STAFF REPORT 02-08-2023 REGULAR MEETING

APPLICATION NUMBER: 23-8206

ADDRESS: 415 WEST GRAND BOULEVARD

SCOPE: ALTER FRONT AND REAR PORCH, REPLACE WALKWAYS (WORK COMPLETED WITHOUT APPROVAL), INSTALL FENCE

FRONT (GRAND BLVD.) ELEVATION

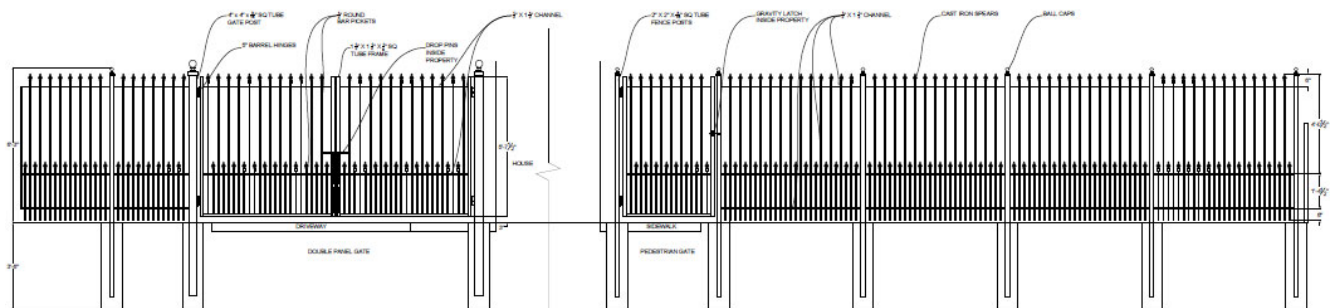
- Based on the analysis described above, it is the opinion of staff that the construction (or reconstruction) of a full-width porch, *in any material*, is not appropriate for this building's style, as it imposes a rigid symmetry on what was originally a balanced asymmetrical composition. The porch deck should only exist below the original off-center historic porch roof, and would be most appropriately designed and built fully in wood, to include wood railings, balustrade, floor, and steps. Metal railings would not be historically appropriate on such a wood porch.

- The as-built design of the new porch detracts greatly from the balance of the historic composition, giving much more visual massing to the new porch than the historic house, which competes with it for attention. A brick porch may perhaps be acceptable in this case given the lack of material integrity present at this property, but only in the historic footprint.

- The brick chosen for the new work, while somewhat similar to the "orange [common] brick" used in the historic foundation and chimney, is a mix of lighter and darker units, which is a modern formulation that unfortunately creates another distracting design element.

- It is staff's opinion, based on the historic offset between the front entrance and the gabled porch roof

roof, that the original front steps would have been centered on the historic porch, and would not have been aligned with only the front door as it is in the as-built condition.

- A full-width porch under a historic porch roof extending only half of the width is a historically inappropriate design for this particular house, which shows that the porch existed only at the right side of the elevation, consistent with its asymmetric expression and original architectural style. A new porch deck should not exceed the historic footprint established by the existing historic porch roof.

- The porch, based on the existing historic porch roof and the asymmetrical composition of the house, would have existed historically only below that roof, oriented to the right (north) side of the façade.
- The porch, including its steps, should be primarily constructed of wood elements; not brick, concrete, or steel

- The legal status of the recently replaced full-width wood/concrete porch remains unclear, and may predate the district's designation.
- Should the Commission approve all or part of the new brick porch for retention, staff recommends that the modern brick should be painted to mask or de-emphasize the distracting variation in the brick mix, and that this paint should be merged into the painted foundation treatment. Combined with wood steps and other wooden porch elements consistent with the existing wooden porch roof and columns, this may reduce the stark impact of the current design, and integrate it more successfully into the historic massing.

Staff therefore recommends that the Commission issue a Denial for the front porch replacement, as it does not meet the Secretary of the Interior's Standards for Rehabilitation, specifically Standards 2, 6, and 9:

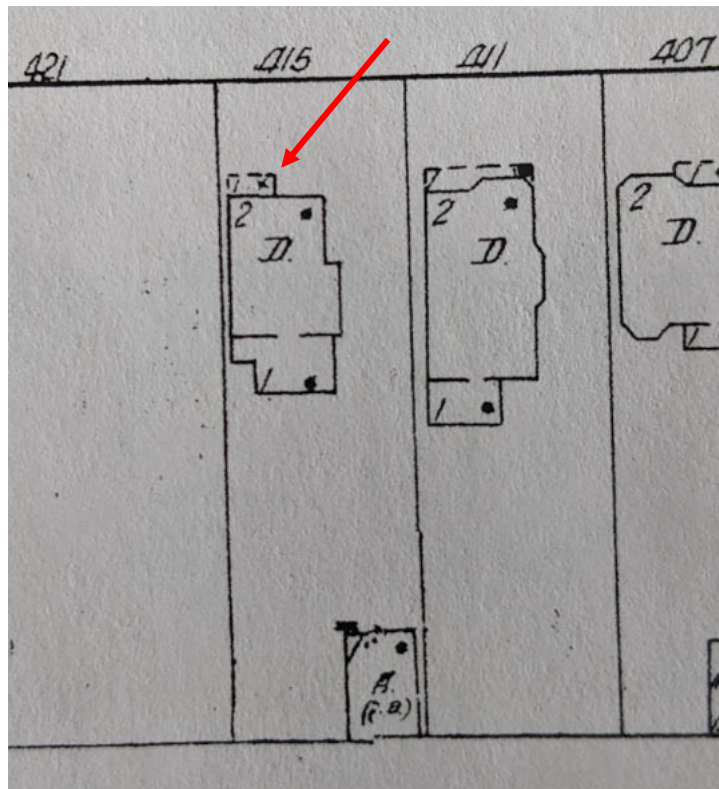
- Wood frame houses of this type often have wood frame porches; when brick appears it is most often an extension of the foundation. Historic-age roofs over wood porches in our climate, with rare exceptions, *cover the entire wooden floor* to slow deterioration. Looking carefully at the “before” photographs submitted by the applicant, staff observes that the portion of the porch to the right of the steps, below the concrete slab (see red arrow) appears to show original conditions in the form of a rectilinear lattice pattern. Note the juxtaposition with the lattice on the opposite (south) side, which shows X-shaped lattice, a modern product widely available in home centers and often incorrectly applied to historic porches.

- A review of the historic Sanborn maps for this property show that the original porch, per the extant roof and columns, was situated only at the *right* side of the front elevation, and did not extend the full width of the house. See arrow below.
